ARCHITECTURAL REVIEW BOARD

LOCATION: 2020 "H" Street

PROPOSAL: One Story Building Over Swimming Pool

FLOOR PLAN

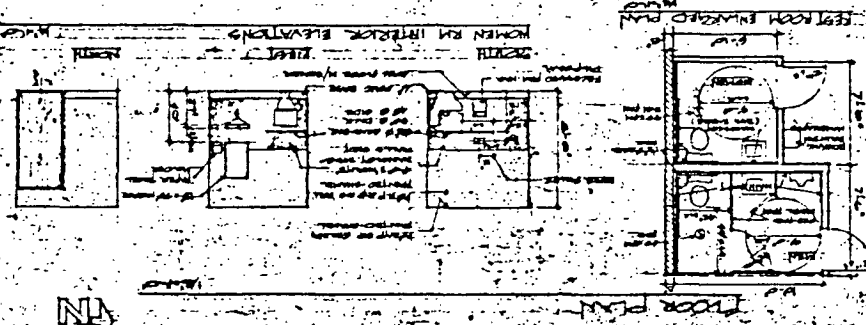
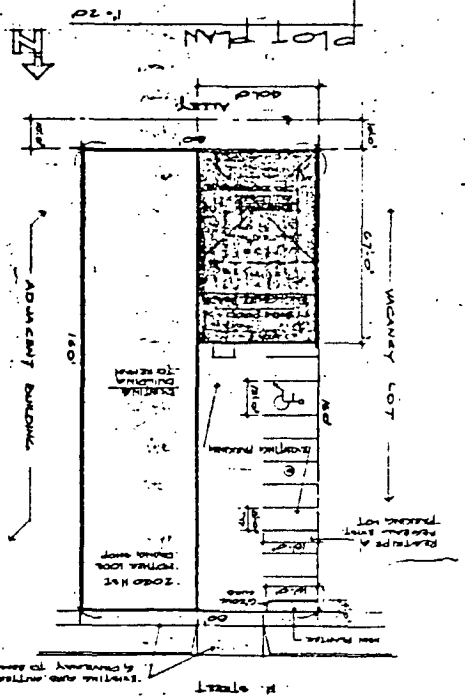
space as outlined in the Zoning Ordinance. The four foot wide planting area will be provided at the front of the parking area. Staff suggests that an additional planting area be provided in front of the building to the south of the last marked parking space. This will not hamper access into the structure nor will it close off any light coming through the front windows of the project. Staff suggests that maximum landscaping be placed along the front of the building in order to cover up the harshness of the prepainted metal facade.

1. The applicant will provide landscaping between the southern most parking stall and the front of the building. This landscaping will be maximized in order to provide plant cover in front of the building.
2. The west wall of the new building shall be painted to match the color of the metal wall panels.
